DEVELOPMENT SERVICES ENGINEERING PLANS REVIEW

LEGAL ADDRESS: 1501 Alton Road

PLAN DESCRIPTION: Financial Institution (Savings of America)

SAVINGS OF AMERICA
 ALTON ROAD BRANCH
 MIAMI BEACH, FLORIDA

Grading Plan

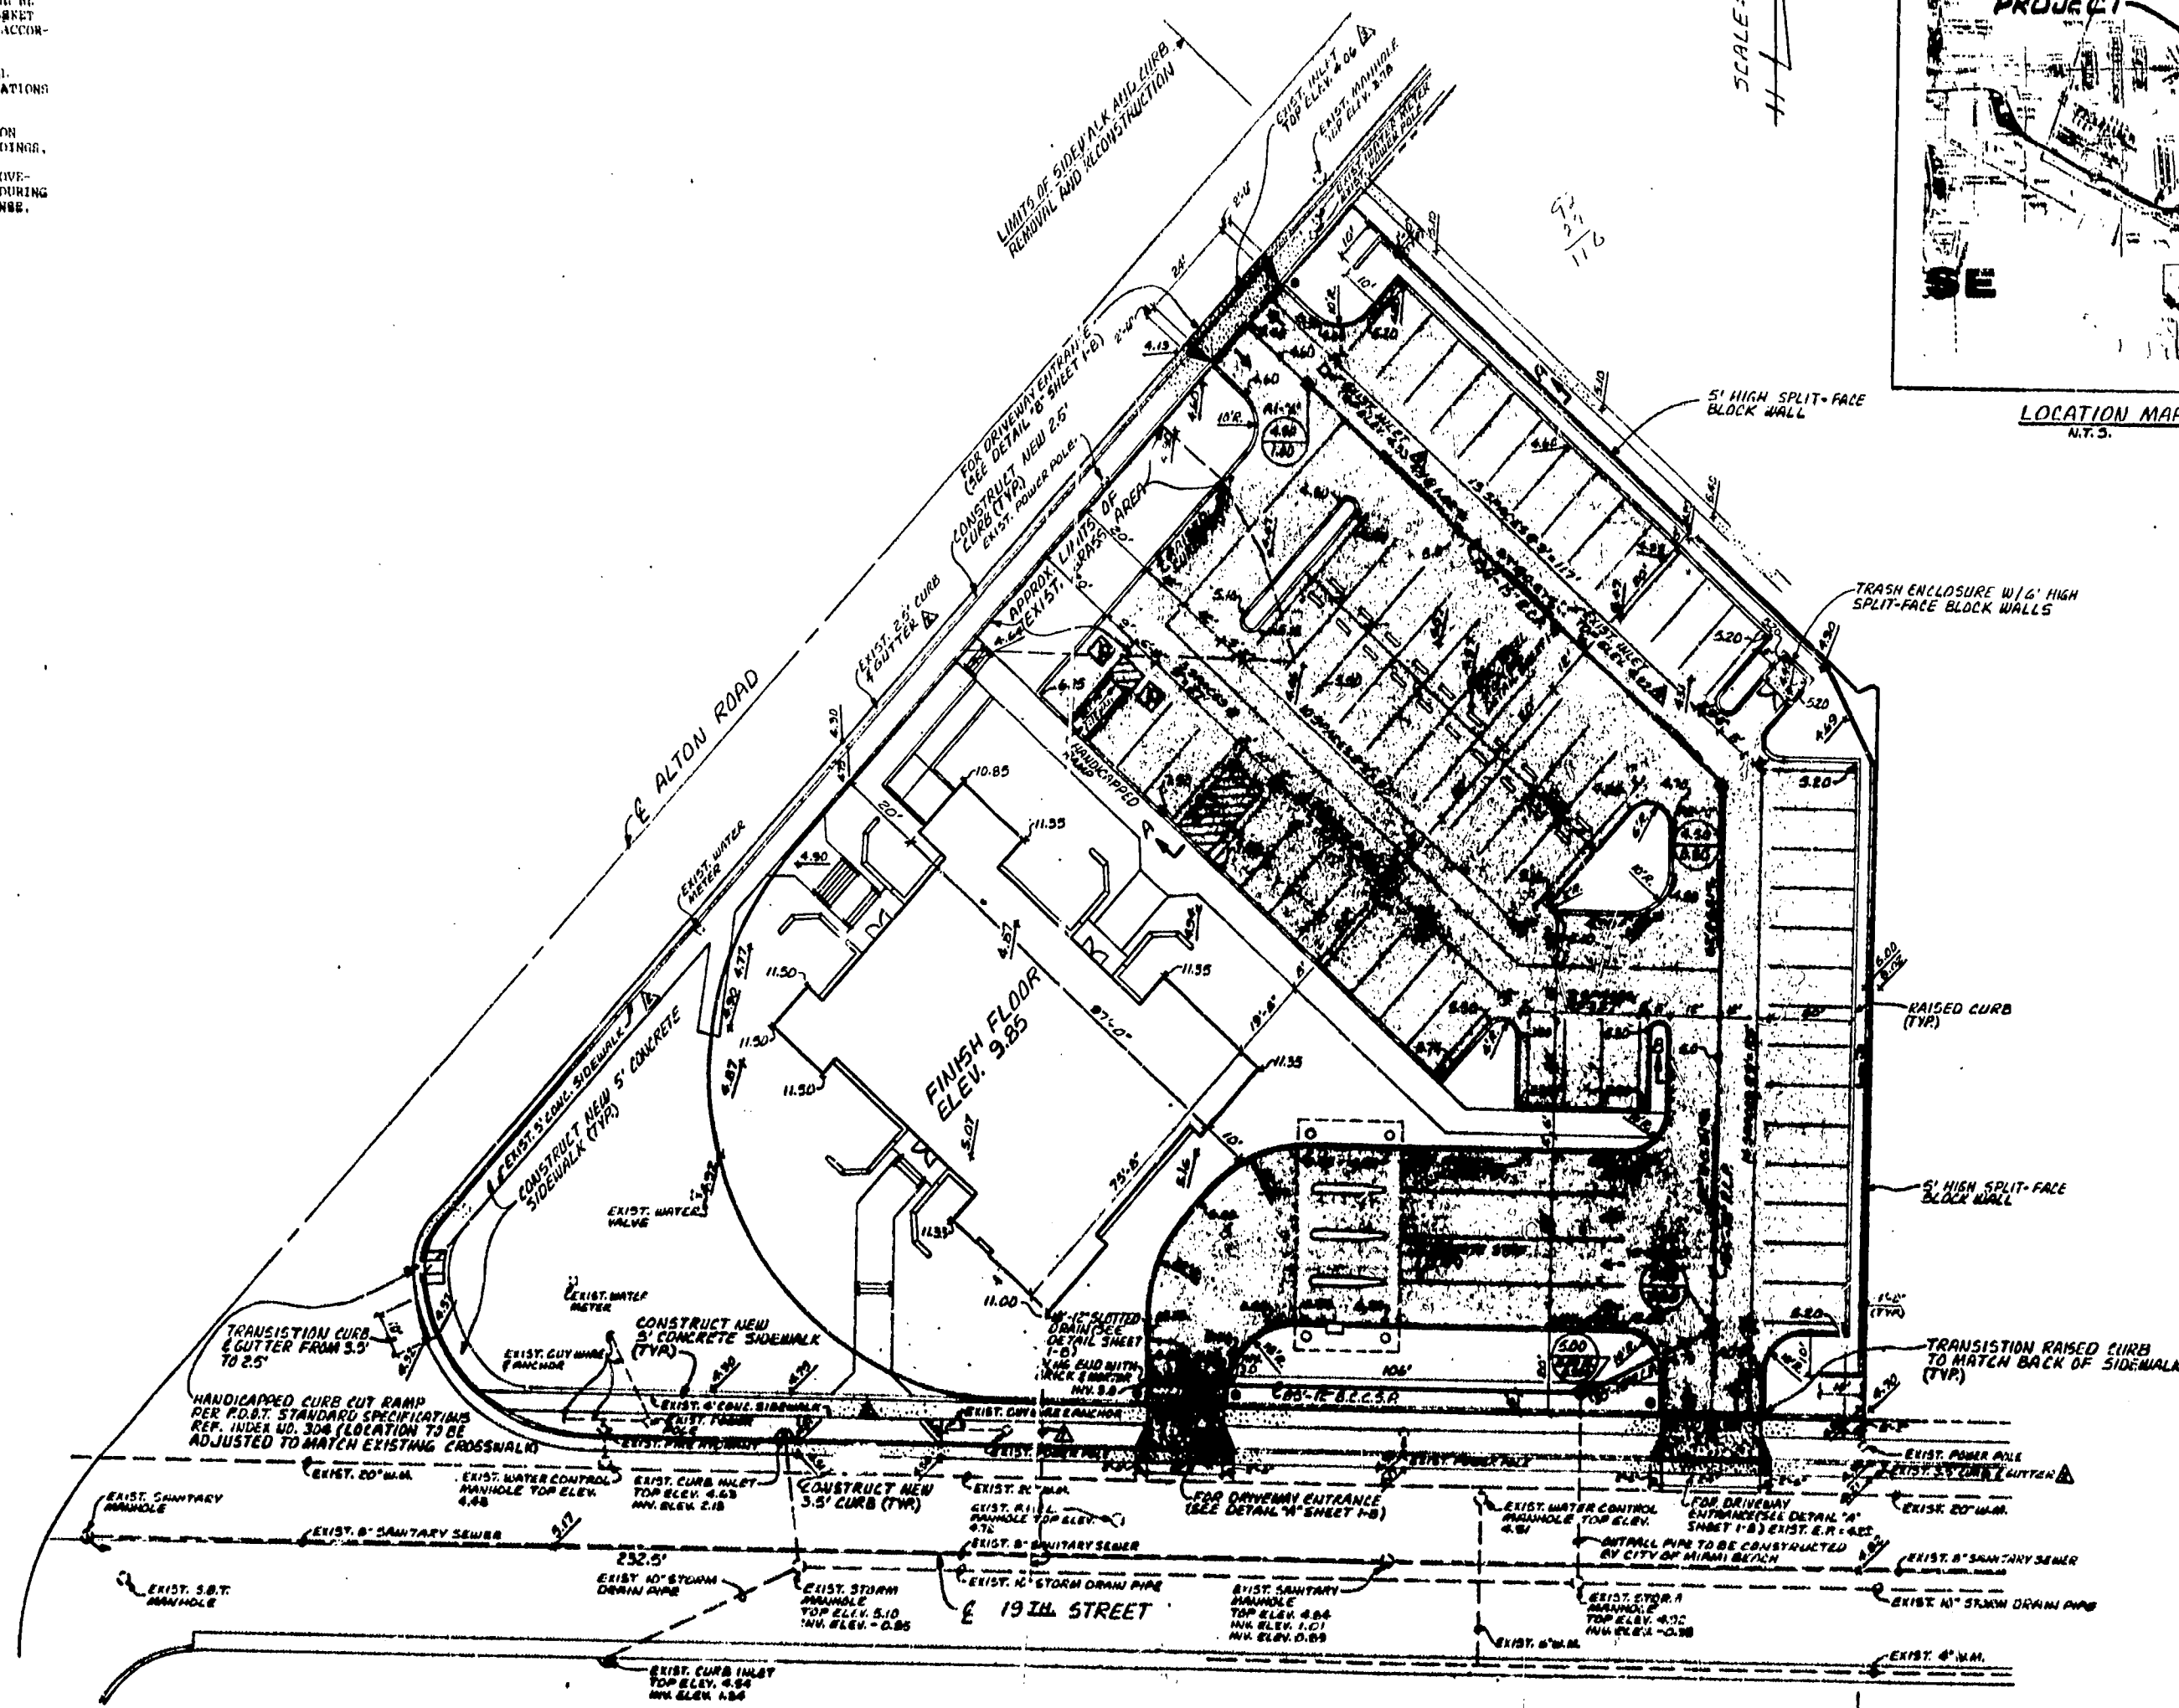
SANITARY SEWER: To use existing facilities-to be field checked by Public Works. Garbage disposal units not permitted.

DRAINAGE: See Note #2
Slope yards to be sloped so as to not shed water to neighboring properties. A/C condensate to be piped to sewer drainage well to be located on private property.

GRADES: To meet Federal Flood Insurance criteria of +9.00 MSL (+9.85 U.S.L.L., Bay Datum)

Note #2 - Public Works Dept. to estimate cost for extending storm pipe from manhole to property line.
